**CITY OF ALAMEDA
HARRINGTON FIELD RESTROOM FIRE DAMAGE REPAIR/RESTORATION
No. P.W. 03-23-05
ADDENDUM NO. 1**

Addendum No. 1 is hereby issued to make the following revision to the plans and specifications. Please note deletions are shown in ~~strikeout~~, additions are shown in **bold italics**:

**TECHNICAL SPECIFICATIONS
WITH ADDENDUM 1 CHANGES**

Figure 1 Harrington Restroom Exterior

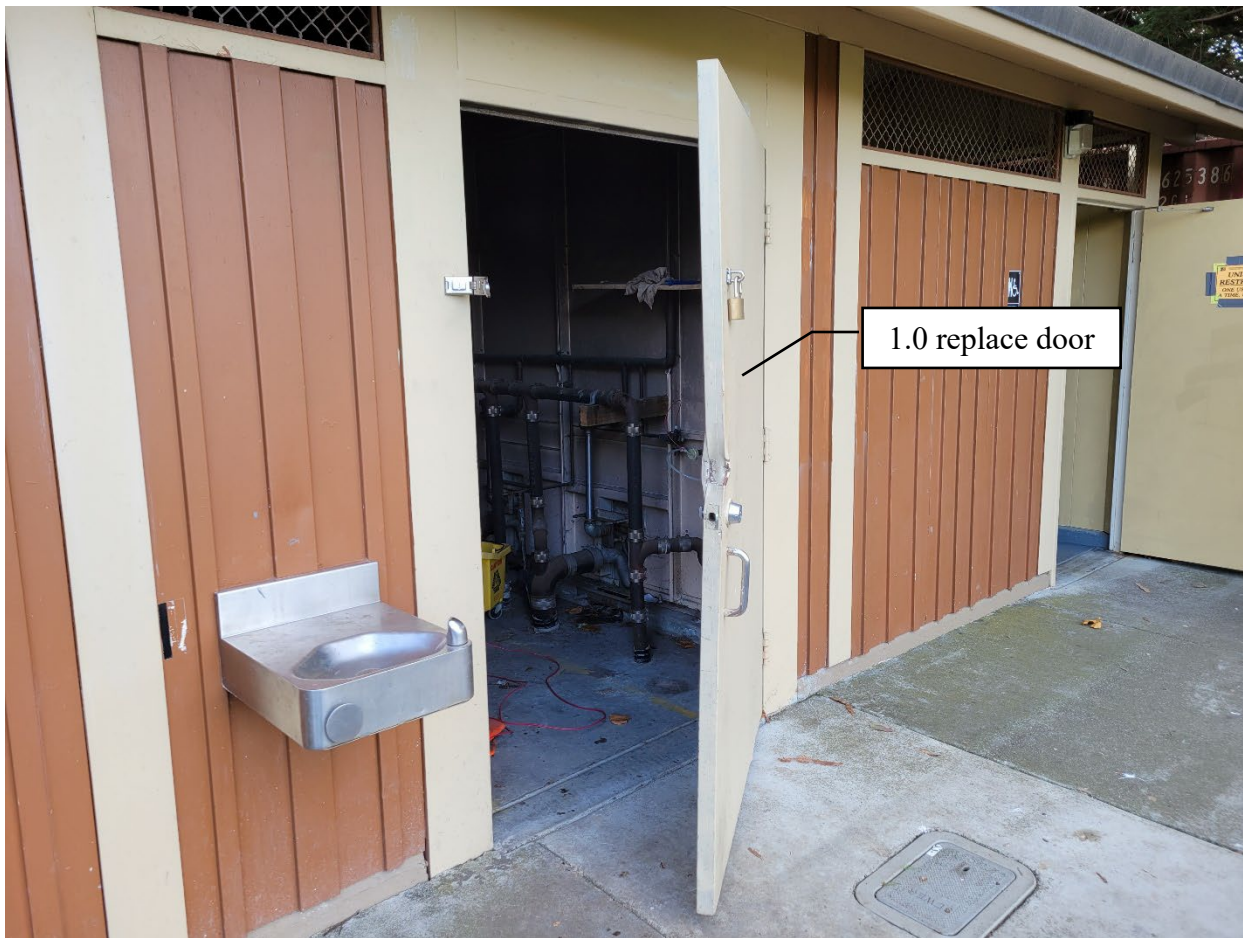
Addendum 1: Bid Item #1 includes all work inside of the Men's restroom and Utility closet as called out and described in the following pages. All ancillary/support work to complete this scope should be included the lump sum price for this bid item. This is included but not limited to: site security, pedestrian control, disposal of all demolition and construction waste and materials, housekeeping, and project administration (submittals, shop drawings, etc.)

Addendum 1: Paint Complete Exterior (Bid Item Alternate #2)

Bid Item Alternate #2 includes re-painting of all exterior surfaces in two colors, exterior grade paint. Work shall include cleaning, prep, and priming of all surfaces in accordance with manufactures specifications. The City uses Sherwin Williams Paints. Body color: Bunglehouse Blue 0048. Trim Color: Icicle 6238

Figure 2 Harrington Utility Closet Door

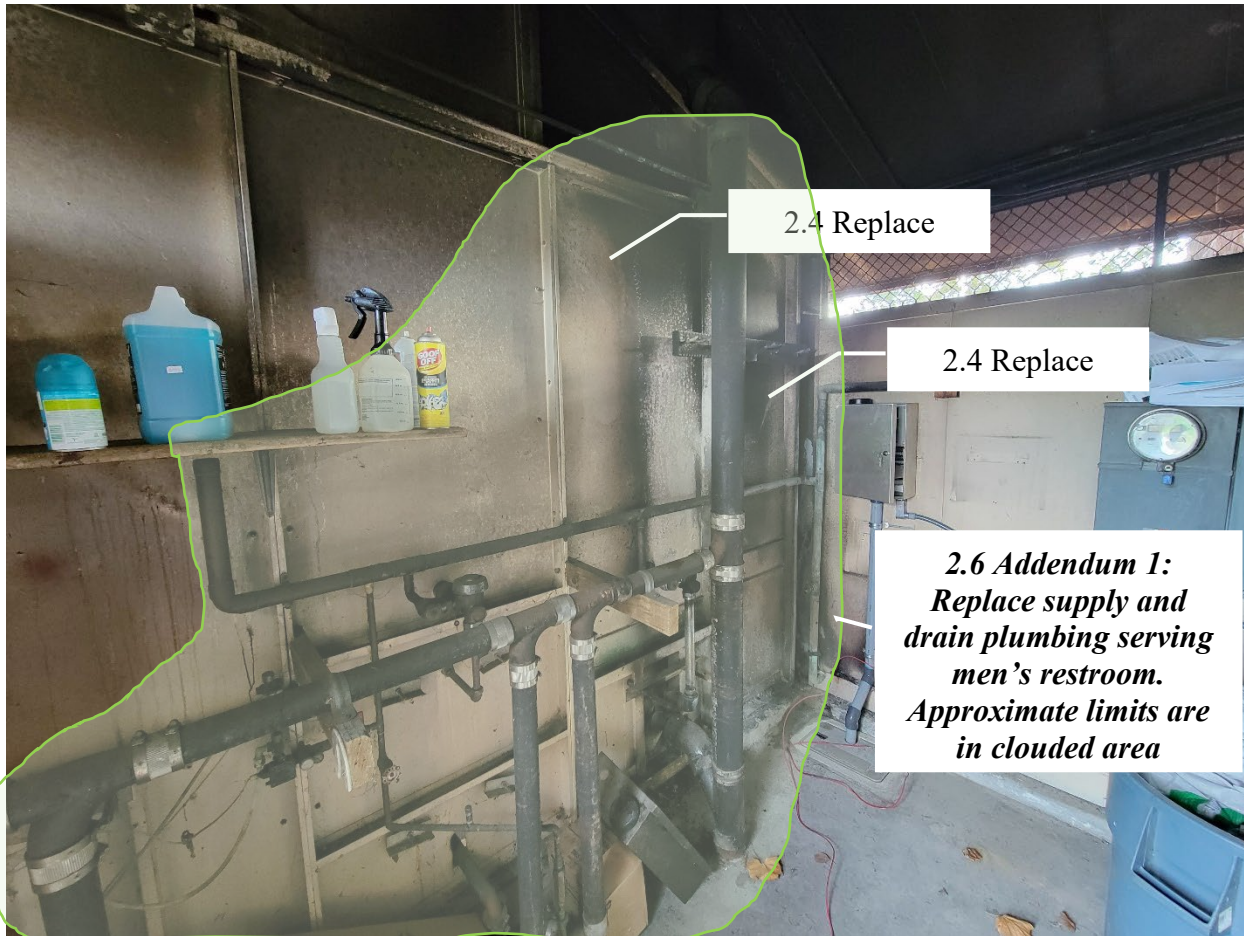
1. Scope – Exterior (Bid Item #1)

- 1.1. Replace Metal Doors. **Addendum 1: all three doors to be replaced in-kind**
- 1.2. Door and frame to be replaced in-kind
- 1.3. City to provide details of lock hardware **Addendum 1: Schlage ND70PD, RHO lever, 626 finish: ND70PD RHO 626**
- 1.4. Paint to match existing
- 1.5. **Addendum 1: Furnish and install new door closer for restroom doors suitable for installed door material and weight.**
- 1.6. **Addendum 1: Clean smoke/fire residue from back wall and soffit and prep/prime/paint to match existing.**
- 1.7. **Addendum 1: all paint, primer and coatings for both exterior and interior surfaces shall be exterior grade and compatible with the substrate being painted. Apply the number of coats specified by the**

manufacturer for this application. All surfaces shall be cleaned/prepped and primed in accordance with manufactures instructions.

Figure 10 Addendum 1:Harrington Utility Closet Electrical

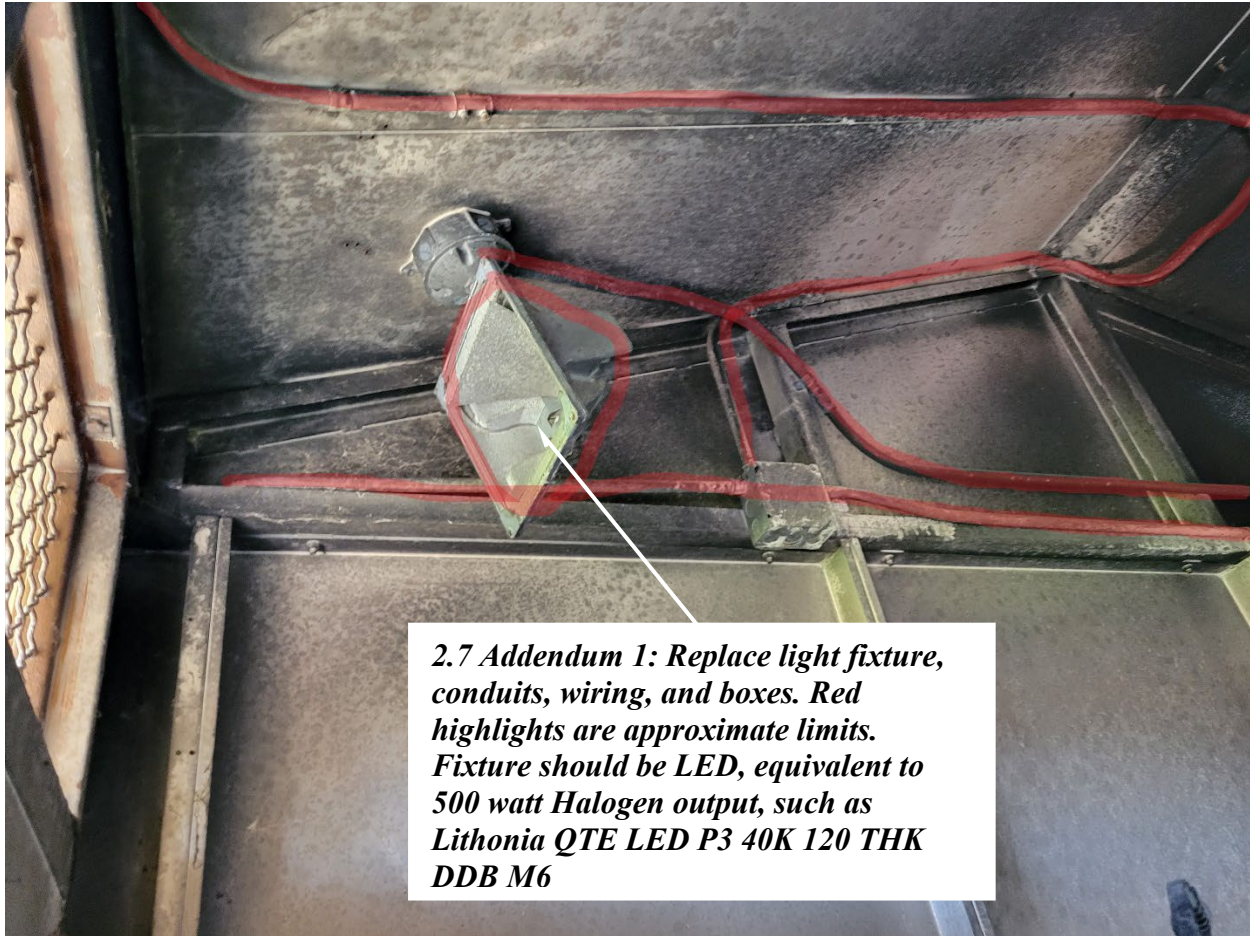
2.7 Addendum 1: Replace light fixture, conduits, wiring, and boxes. Red highlights are approximate limits

Figure 14 Harrington Men's Stall 1

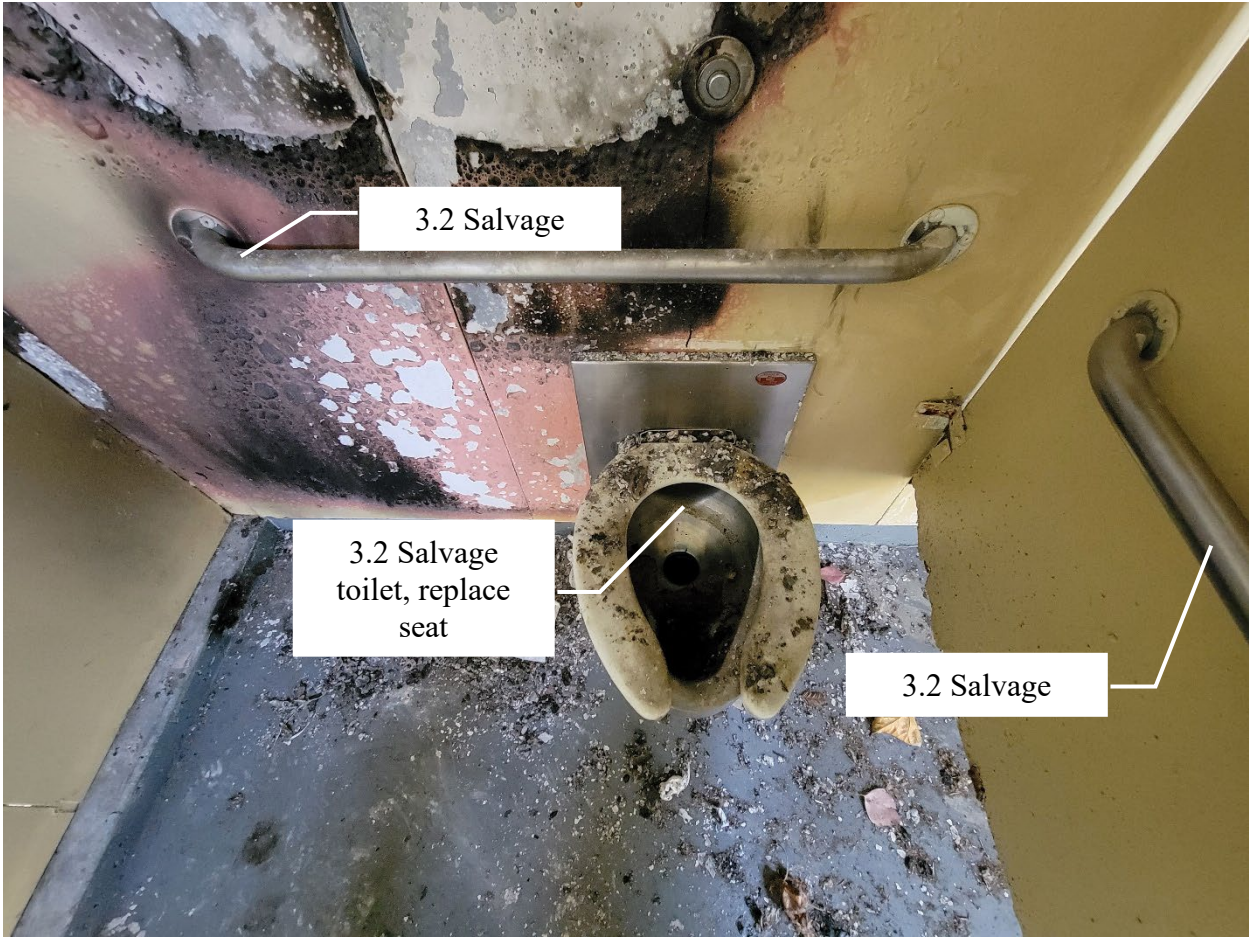
3. Scope – Men's Restroom (Bid Item #1)

- 3.1. Remove all fire damaged fittings and fixtures including stall partition and doors.
- 3.2. Salvage and clean fixtures when possible (assume toilet, grab bars, and toilet paper dispenser are salvageable).
- 3.3. Clean all walls, ceilings, and surfaces to remove dirt and soot from fire.
- 3.4. Paint all new and cleaned/salvaged surfaces to match existing
- 3.5. Install new partitions and doors (product to match existing or similar, as approved by the City Project Manager).
- 3.6. Install fixtures (grab bars, toilet, toilet seat, toilet paper dispenser) with salvaged fixtures or new where required.
- 3.7. Addendum 1: Replace light fixtures with existing model or equivalent. Existing is Enertron 7026 - L**
